GRAND COUNTY Planning Commission

TITLE:	Sandstone Cliffs Preliminary Plat Application Review
FISCAL IMPACT:	N/A
PRESENTER(S):	Community and Economic Development Staff

STAFF REPORT

Sandstone Cliffs Subdivision

Carroll Drilling LLC	
Sandstone Cliffs Subdivision Slope Analysis	
Map Name: H:\JD\Pro\1711-279\Design\GIS\Maps\Sandstone_Cliffs_Subdivision_Slope_Analysis.mxd	
Project Number: 1711-279	Drawn by: JEM 01-18
Last Edit: 01/04/2018

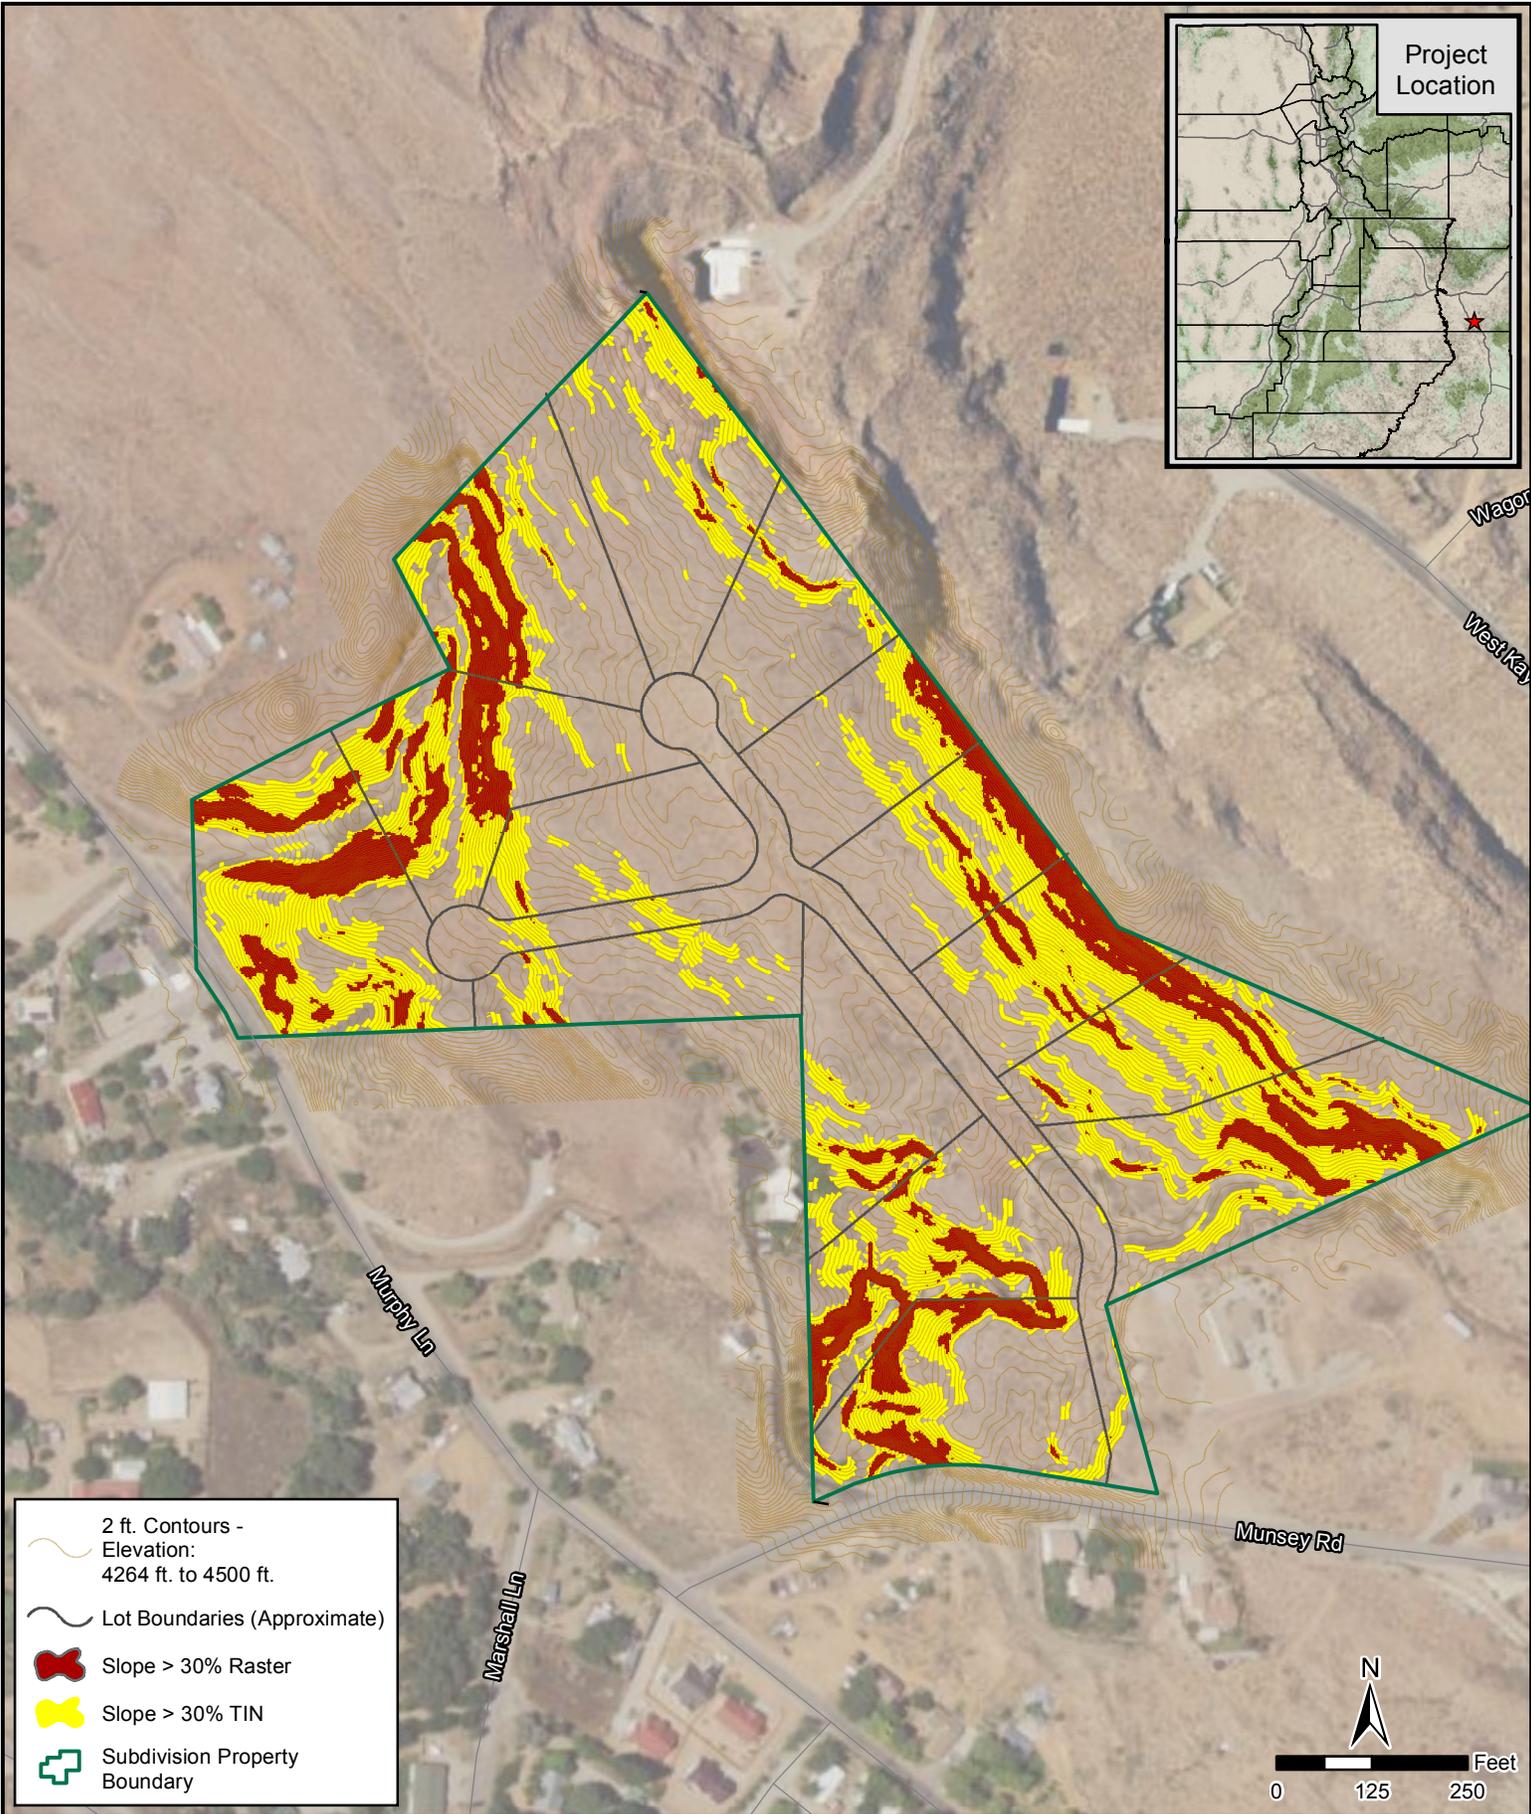
I have included an exhibit showing the areas within the subdivision with excessive slopes for your reference. Additionally, the lot areas are shown on the sketch plan submittal. We ask that you review the calculations and confirm that we have accounted for the excessive slopes in the minimum lot size as described in the Grand County land use code.

Carroll Drilling LLC	
Sandstone Cliffs Subdivision Slope Analysis	
Map Name: H:\UD\Proj\1711-279\Design\GIS\Maps\Sandstone_Cliffs_Subdivision_Slope_Analysis_Revised.mxd	
Project Number: 1711-279	Drawn by: KWC 10-18
Last Edit: 10/23/2018

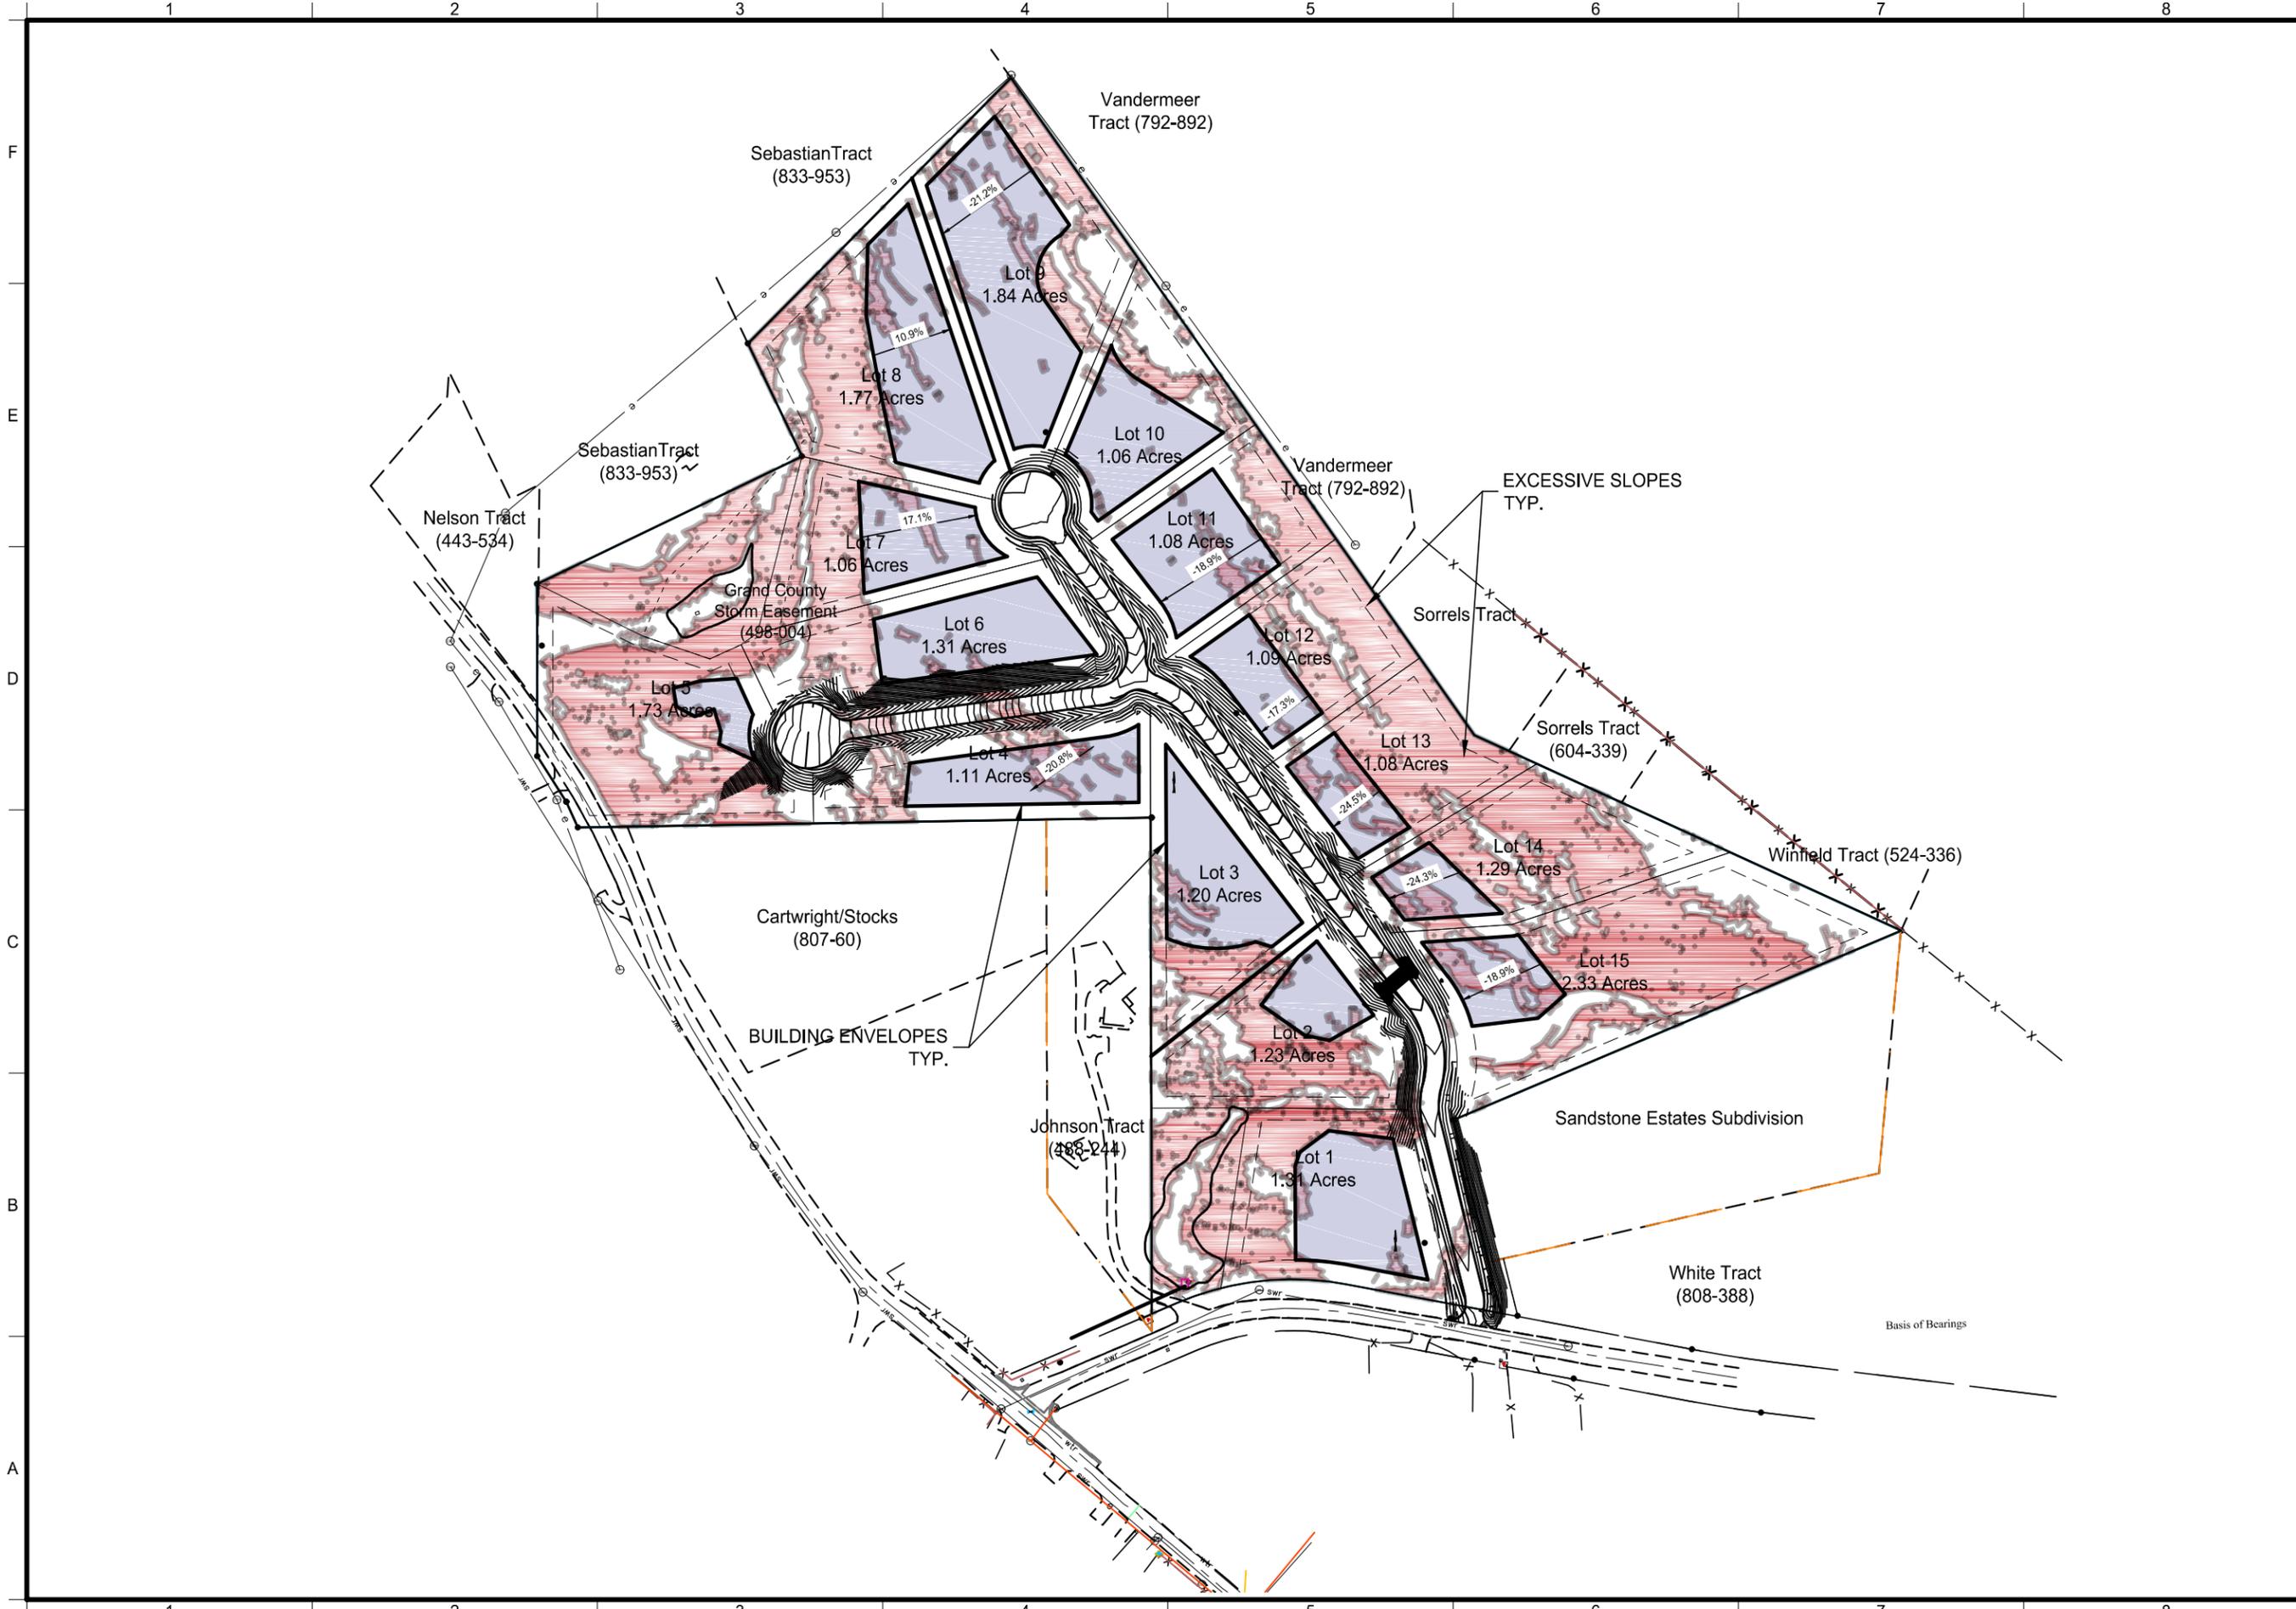
During the same October 9, 2018 meeting, the planning commission asked the Applicant to call out and show the building envelopes clearly on the recorded plat. Prior to the October 25, 2018, upon the recommendation of a planning commissioner, Staff evaluated the accuracy of the Applicant’s slope analysis and found errors. As a result, the building envelopes proposed at that time were not accurate relative to the actual topography. The slopes analysis and building envelopes on the preliminary plat have been corrected. Staff confirms that the Applicant is still entitled to the same number of lots.

Cricket asks if PC members participated in any ex parte communication. She feels it is inappropriate to have conversations about items over email and prefers staff relay messages and updates about agenda item updates. Kaitlin clarifies that staff is not aware of any ex parte communication of the PC members and that the slope analysis was staff-driven after a clarifying question from Kevin.

Kevin moves to table until the Planning Commission receives a revised plan to show updated slope analysis and building envelopes, and a trail easement. Rachel seconds. During discussion, Abby asks for better clarification about trail designations in the Trail Mix master plan. For 3 (Kevin Walker, Abby Scott, Rachel Nelson), 2 against (Emily Campbell, Cricket Green). Motion fails.
